July 2, 1991

SUBJECT: Calvert Cliffs Nuclear Power Plant
Unit Nos. 1 & 2; Docket Nos. 50-317 & 50-318
Single-Failure-Proof Upgrade and Technical Specification Change Request;
Spent Fuel Cask Handling Crane

EDR-1 APPENDIX B SUPPLEMENT
SUMMARY OF PLANT SPECIFIC CRANE DATA SUPPLIED BY EDERER
FOR CALVERT CLIFFS AUXILIARY BUILDING CRANE

EDR-1 APPENDIX C SUPPLEMENT
SUMMARY OF REGULATORY POSITIONS TO BE
ADDRESSED BY THE APPLICANT
FOR CALVERT CLIFFS NUCLEAR POWER PLANT
AUXILIARY BUILDING CRANE MODIFICATIONS

DRAWING A, SH. 1

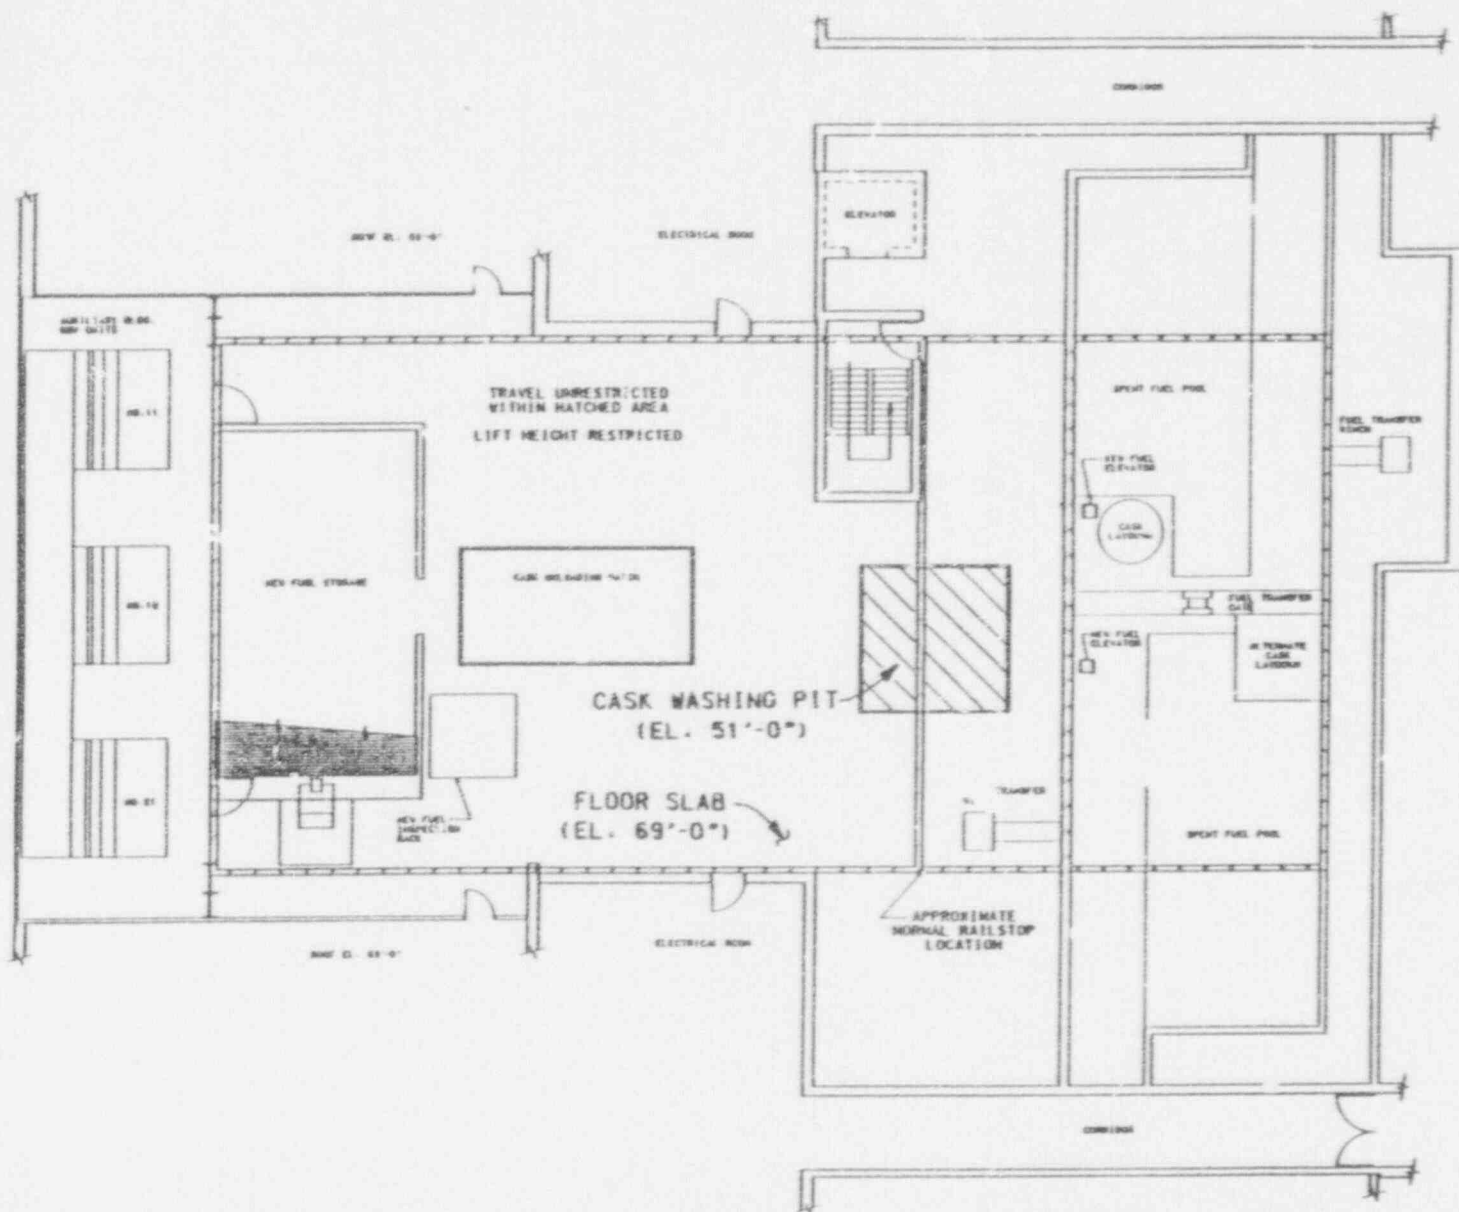
| Regulatory Position | Topical Report Section | Information to be Provided | Specific Crane Data |
|------------------------|------------------------------|---|--|
| C.2.c | III.C (C.2.c) | 1. Location of safe laydown areas for use in the event repairs to the crane are required that cannot be made with the load suspended. | 1. Drawing "A", Sheet 1, shows the laydown areas that can be used in the event that repairs to the crane are required that cannot be made with the load suspended. |

THIS DRAWING DEFINES THE SAFE LAYDOWN AREA FOR "HEAVY LOADS" SUSPENDED FROM THE SPENT FUEL CASK HANDLING CRANE AFTER THE CRANE HAS LOST SINGLE-FAILURE-PROOF CAPABILITY. A HEAVY LOAD IS DEFINED AS ANY LOAD GREATER THAN 1600 POUNDS PER NUREG 0612. THE SAFE LAYDOWN AREA IS LIMITED TO THE CASK WASHING PIT AT EL. 51'-0".

DRAWING A, SH. 2

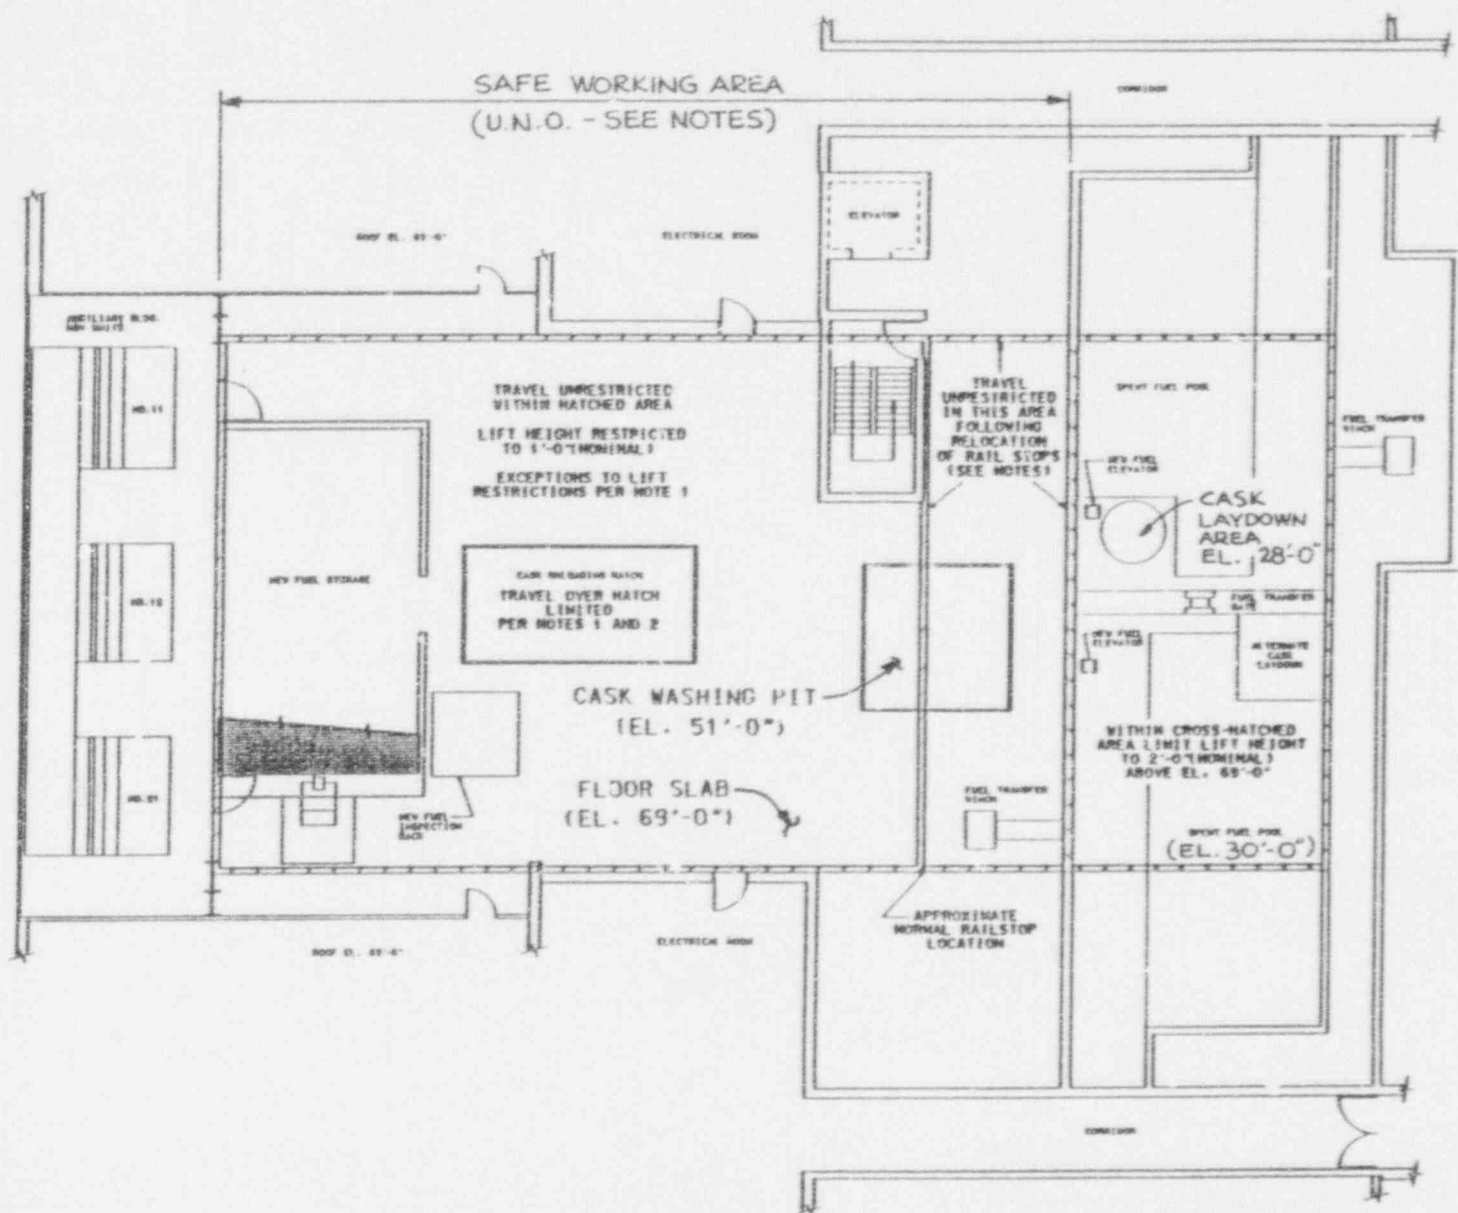
1. THE PURPOSE OF THIS DRAWING IS TO SHOW THE AREA TO PARK THE SPENT FUEL CASK HANDLING CRANE AFTER THE CRANE HAS LOST SINGLE-FAILURE-PROOF CAPABILITY AND REPAIRS NEED TO BE MADE. LIFTS REQUIRED TO MAKE REPAIRS MAY BE PERFORMED WITH NON SINGLE-FAILURE-PROOF CRANE SUBJECT TO RESTRICTIONS PROVIDED ON THE DRAWING AND IN THE FOLLOWING NOTES:

- a. FOR LOADS CARRIED OVER FLOOR AREA WEST OF SPENT FUEL POOL, LIFT HEIGHT IS RESTRICTED AS FOLLOWS:

- 1. 14,000# - 18'-0" (NOMINAL)
- 2. 50,000# - 3'-6" (NOMINAL)
- 3. 50,000# - 1'-6" (NOMINAL)

ANY LIFT OVER 1'-6" (NOMINAL) REQUIRES APPROVAL OF APPROPRIATE AUTHORITY. LOADS SHOULD BE CARRIED AS LOW AS PRACTICAL.

- b. RAISING, LOWERING, OR TRAVELING LOADS OVER THE UNLOADING HATCH AREA IS TO BE AVOIDED. LOADS 6000# REQUIRE APPROVAL OF APPROPRIATE AUTHORITY.
